Re: Docket No. FD 36889, Nevada Gold Rail LLC - Construction and Operation Exemption – Line of Railroad in Eureka and Lander Counties, Nevada; Information Request No. 2

Please find below Nevada Gold Rail LLC's (Nevada Gold Rail) response to Information Request Number 2, received from the Surface Transportation Board, Office of Environmental Analysis (OEA) on May 7, 2026.

Image 1 - Historic Barrick Lek Location

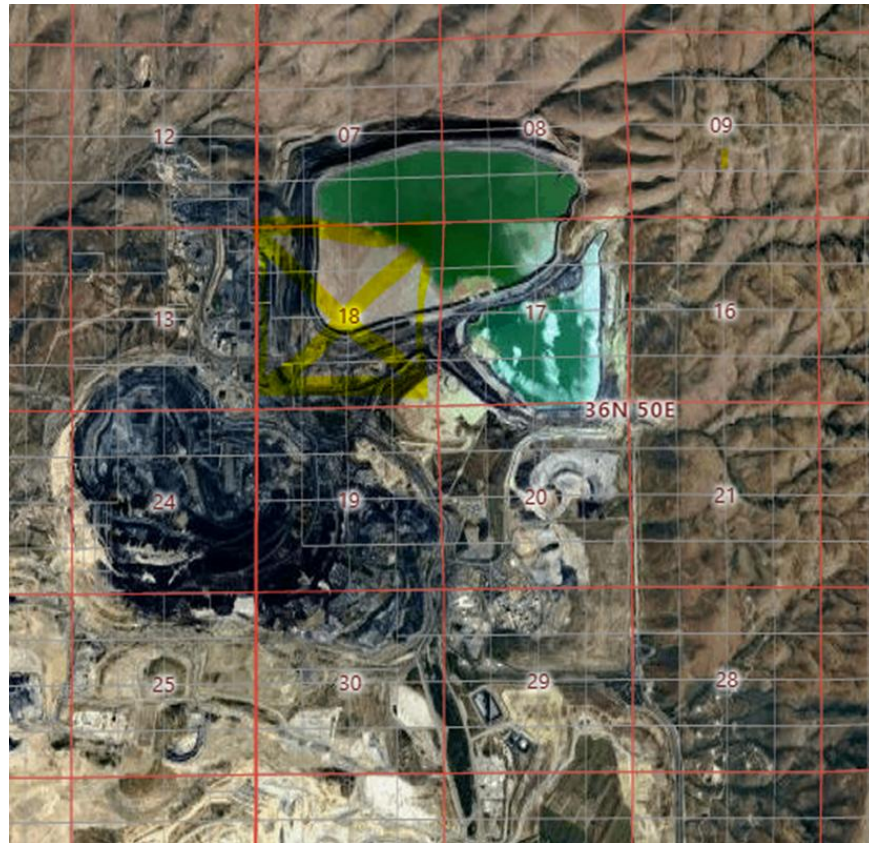
2. Describe NGM Rail's current and planned greater sage grouse lek monitoring in either Boulder Valley or Crescent Valley. Provide the most recent (post-2022) lek monitoring data, if available.

NGM hires a third-party contractor to conduct annual lek monitoring at the Cortez mine only. Additionally, the USGS conducts lek monitoring at other lek locations in the vicinity of the Cortez mine, so data is distributed between two sources. The 2025 Cortez lek monitoring report is attached in the .zip file and Appendix B of the report contains a summary of the USGS data. NGM submitted a general data request to the NDOW to confirm the presence of leks located within four miles of the alignment options NGM proposed to carry forward into detailed analysis, and the data requests are attached with this submittal. NDOW identified one sage-grouse lek within 4 -miles of the range front area, New Brock Canyon. This lek is surveyed by the USGS and was active in 2025. The annual survey report is attached with this letter. However, note that specific sage-grouse data needs to remain confidential per data sharing agreements with NDOW.

NDOW also identified a single lek known as the Barrick lek occurring within 4-miles of the proposed rail alignments in Boulder Valley. NDOW indicated this lek has an unknown status and was last surveyed in 2007, and it has been removed from USGS habitat maps. The lek is located in section 18 of Township 36N Range 50E between the Betze pit, the Goldstrike roaster, and the tailings facility. Due to authorized mining infrastructure and mining activities that have been ongoing in proximity to the lek since the mid to late 1990s, this lek is not used by sage-grouse, and populations in the area have shifted elsewhere, causing USGS to remove this lek from the habitat maps.
